Permit Number: 070859  
**PERMIT ISSUED**  
AUG 15 2007  
CITY OF PORTLAND

has permission to Install awning: 8' x 22.6' x 30' over rear

**City of Portland, Maine - Building or Use Permit Application**

OWNER:	ARCHETYPE, P.A. ARCHITECTS 48 Lane Wharf Portland, Maine 04101 (207) 772-4012 Fax (207) 772-4056
Project:	BECKY'S DINER PORTLAND, MAINE
Scale:	AS NOTED
Date:	July 23, 2007
Revisions:	
	TEMPORARY SEASONAL AWNING
	A-7

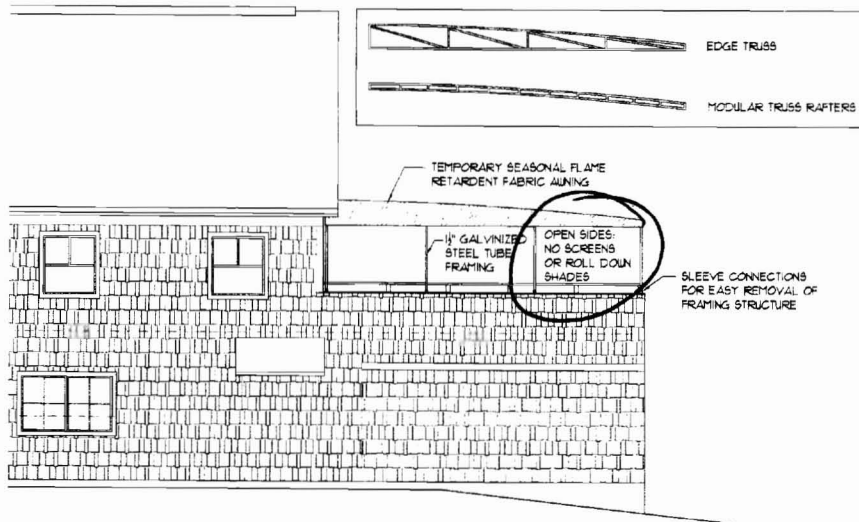
- 1) This permit is being approved on the basis of revised plans submitted on 7/23/07. Any deviations shall require a separate approval before starting that work.
- 2) It is understood that there will be absolutely NO SIDES on this temporary, seasonal awning. Sides of ANY type will cause your establishment to be in violation of your approved site plan and of the WCZ Zone in which you are located. Your current approved addition maximized the allowable area that you could expand for the life of the building.
- 3) It is understood that there is no signage or logos on this awning.

7/17/2007-mes: called Becky Rand - this "awning" which is a roof and sides, is going over the rear deck which is in violation of the WCZ zone square footage allowance. She might want to appeal, but will be talking to her architect and Maine Bay Canvas. The permit is on hold right now. I also did not get a plot plan and structural plans are missing.

7/26/2007-mes: on 7/23/07 I received revised plans showing only a temporary, seasonal awning with no sides, no screens etc.

critical that this is a temporary, seasonal awning - It does NOT have screens on the sides, nor roll down shades or sides of any kind

NOTE:  
TEMPORARY SEASONAL AWNING TO BE TAKEN DOWN YEARLY ON OCTOBER 31ST AND "FL" BACK UP ON "MAY" ST
